*Landmark Surveying, Inc.*

RE: Vue de Valhalla subdivision department reviews.

**SURVEY REVIEW RESPONSE:**

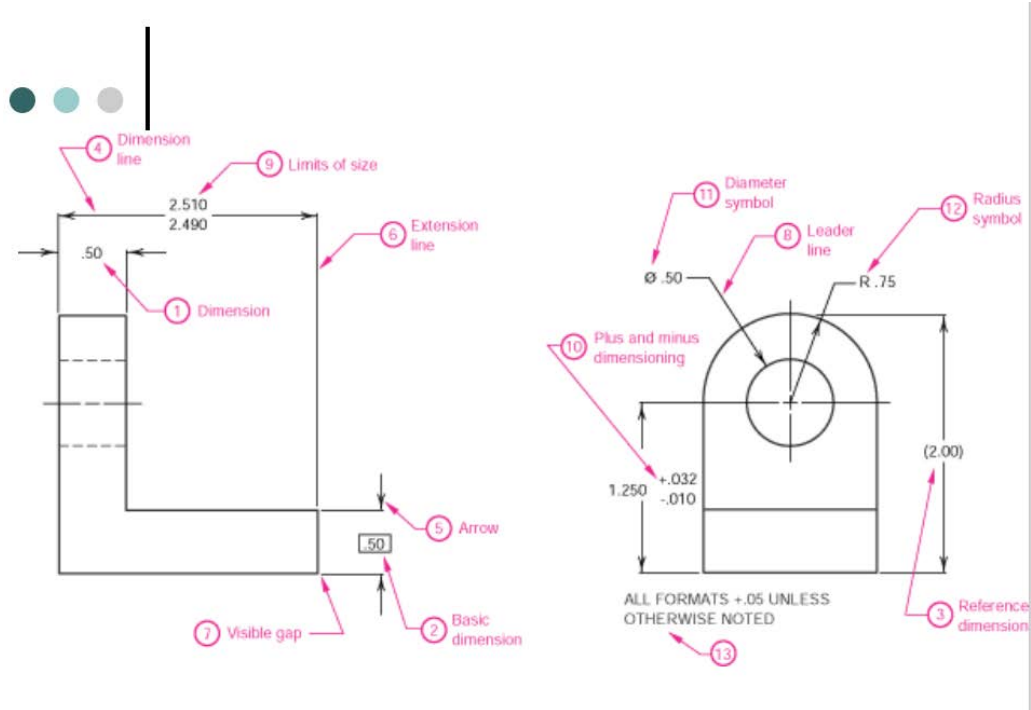
2. The existing location, widths, and other dimensions of all existing or platted land drains, culverts, watercourses, wetlands, streams corridor setbacks, flood plain within and immediately adjacent (within 30') to the tract of land to be subdivided WCO 106-1-5(a)(6). Per response #2 Dimensions of the centerline of the creek running through lot 1 has never been identified in this area for 50' stream maintenance easement. Then the area around the new culvert in the stream is identified.

The approximate center line of the stream is shown and the 50 foot stream setback from highwater line is also shown. The Highwater line is "dimensioned" as is the 25' stream maintenance easement.

It seems to me that there is some confusion related to the meaning of the term "dimension", so with that in mind please accept the following as a brief explanation of the term.

"Dimension is the numerical value that defines the size or geometric characteristic of a feature." <sup>1</sup>
